SUBDIVISION REVIEW SHEET**CASE NO.:** C8-2018-0217.3A**COMMISSION DATE:** September 1, 2020**SUBDIVISION NAME:** Colton Bluff Phase 2**ADDRESS:** 7231 Colton Bluff Springs Road**OWNER/APPLICANT:** KB Home Lone Star LP (John Zinsmeyer)**AGENT:** Carlson, Brigrance, Doering (Geoff Guerrero)**EXISTING ZONING:** SF-4A, SF-4A-CO**JURISDICTION:** Full Purpose**GRIDS:** MK -13**COUNTY:** Travis**AREA:** 12.168 acres**LOT(S):** 64**WATERSHED:** Cotton Mouth Creek**DISTRICT:** 2**PROPOSED LAND USE:** Single Family**SIDEWALKS:** Sidewalks will be installed along both sides of all internal streets.**DEPARTMENT COMMENTS:**

**CITY OF AUSTIN –DEVELOPMENT SERVICES DEPARTMENT
SUBDIVISION APPLICATION – MASTER COMMENT REPORT**

CASE NUMBER: C8-2018-0217.3A
REVISION #: 00 UPDATE: U0
CASE MANAGER: Sylvia Limon PHONE #: 512-974-2767

PROJECT NAME: Colton Bluff Phase 2
LOCATION: 7231 COLTON BLUFF SPRINGS RD

SHEET NO. 1 OF 2

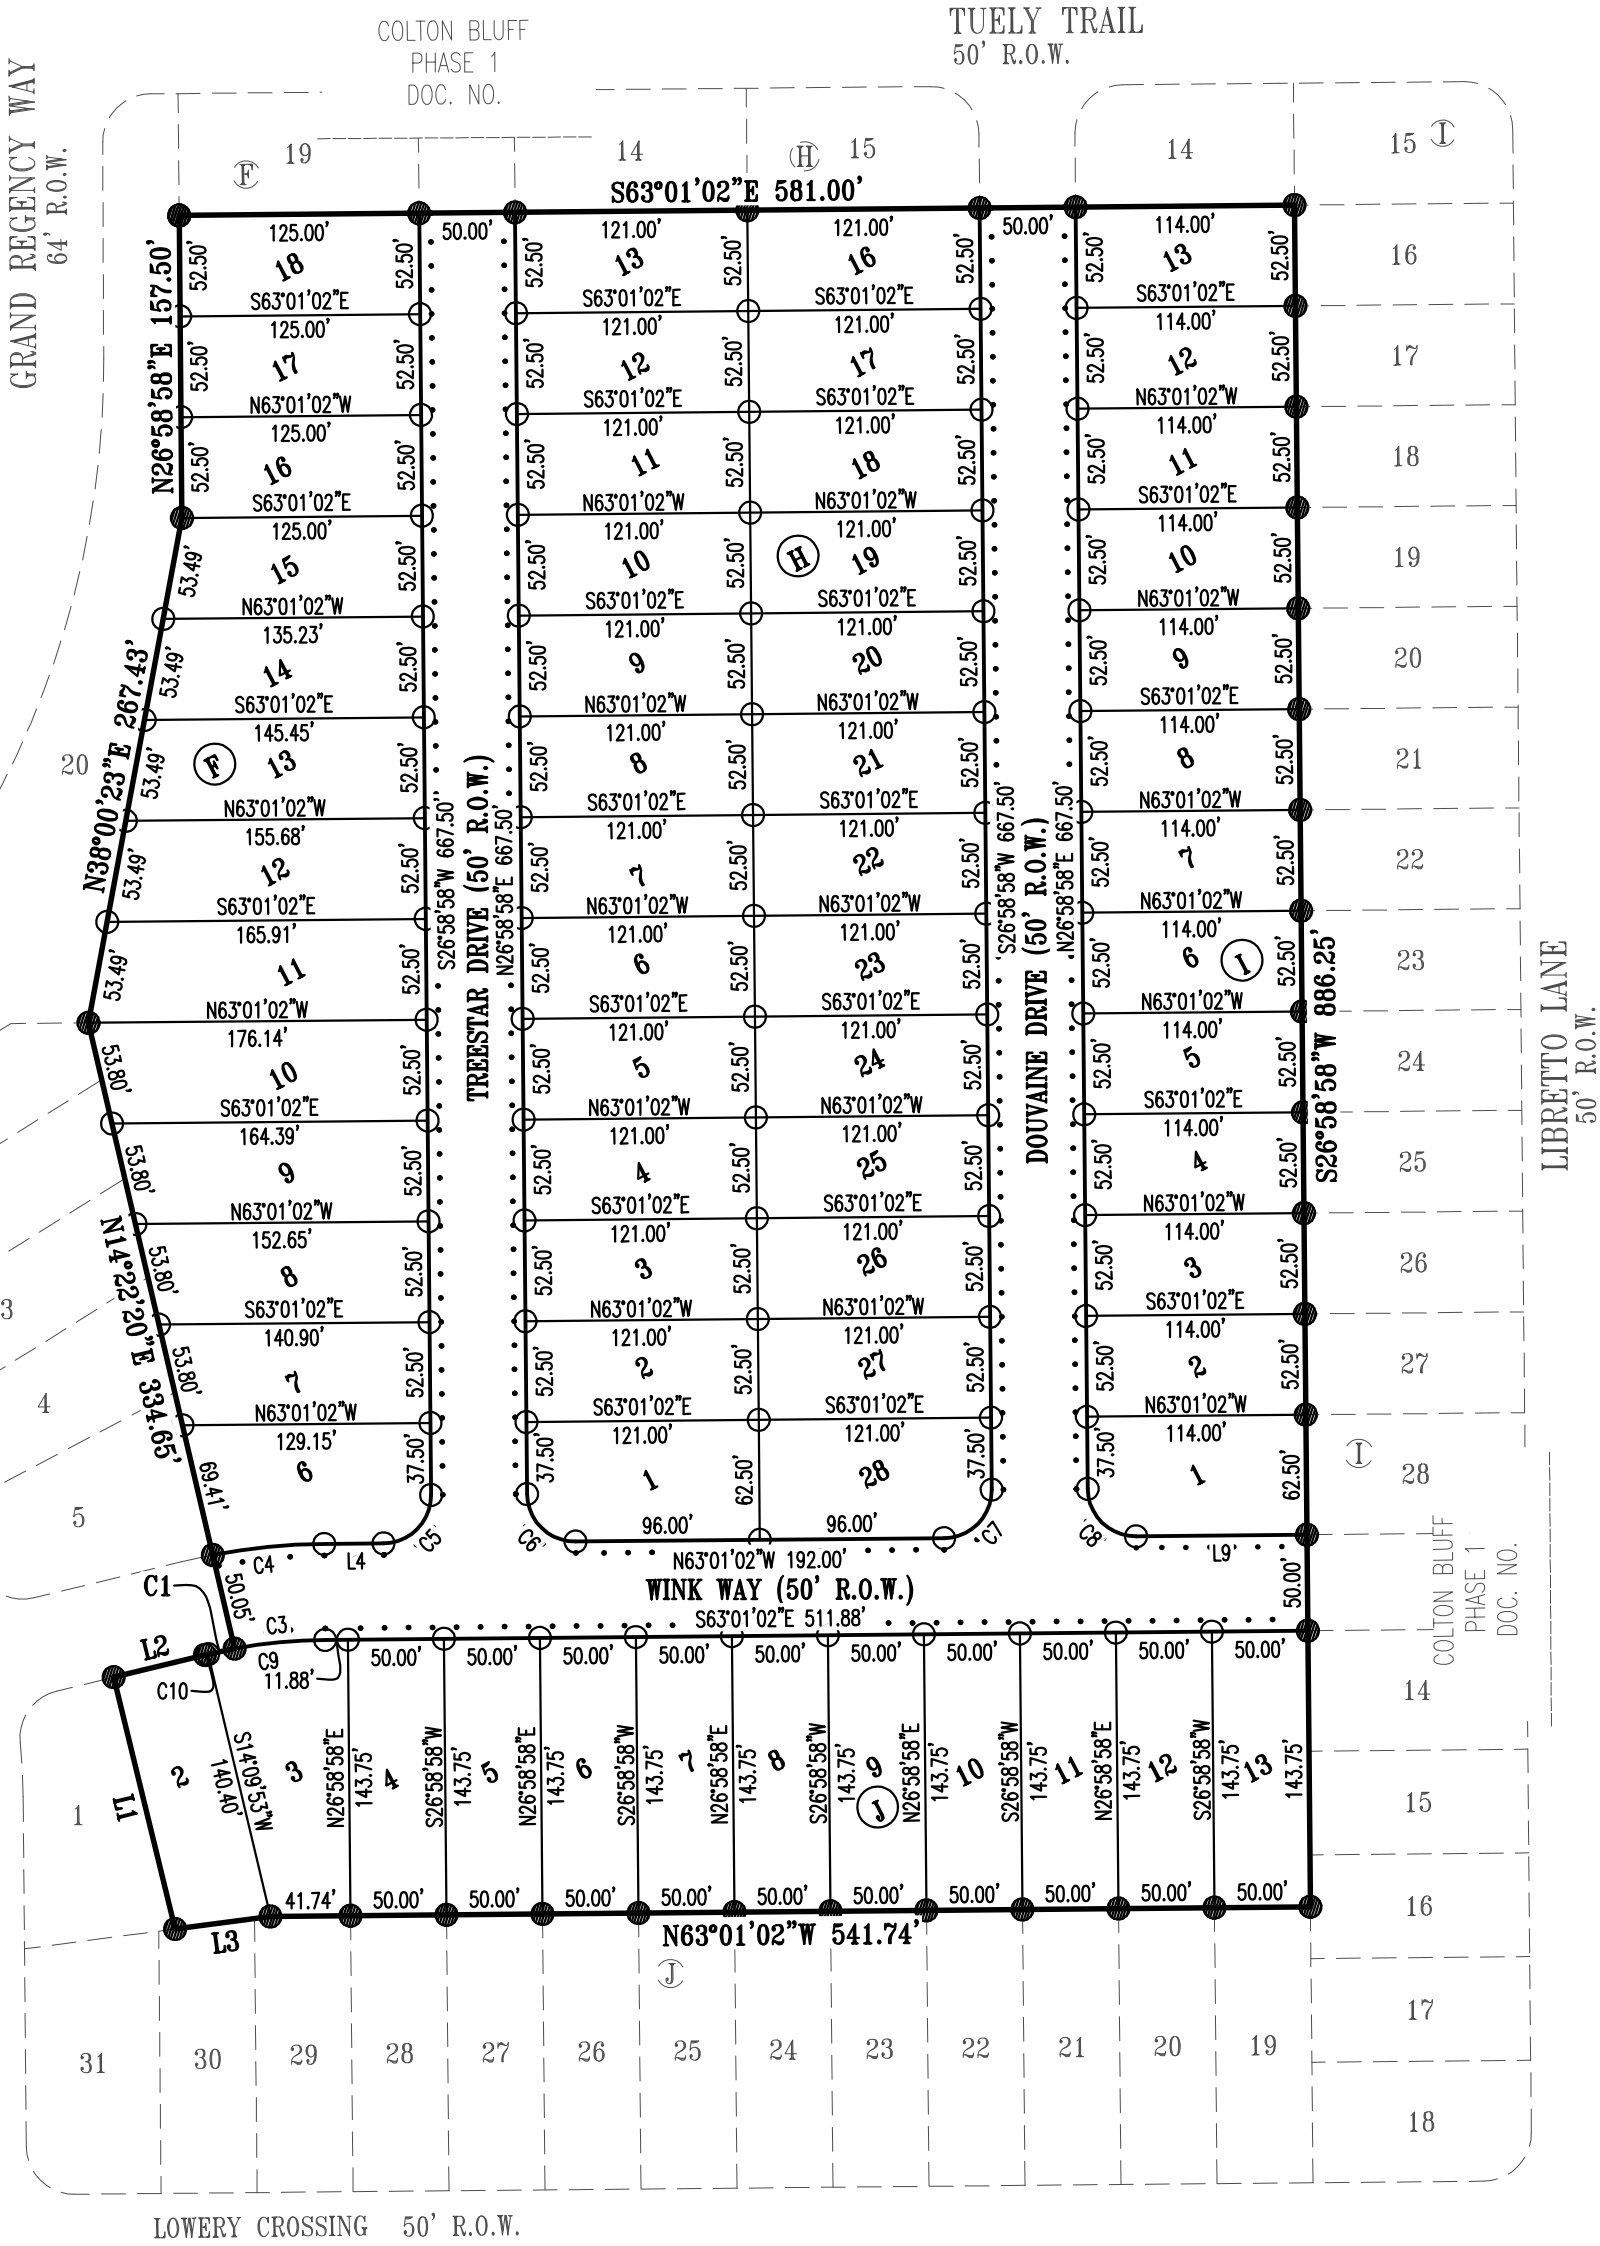
FP comment: Please add/update the FIRM panel number and effective date to the most current map in the note. For this site, the current effective FIRM panel number is 48453C0611 effective on 1/22/2020. (in Preliminary Plans and Engineering Reports)
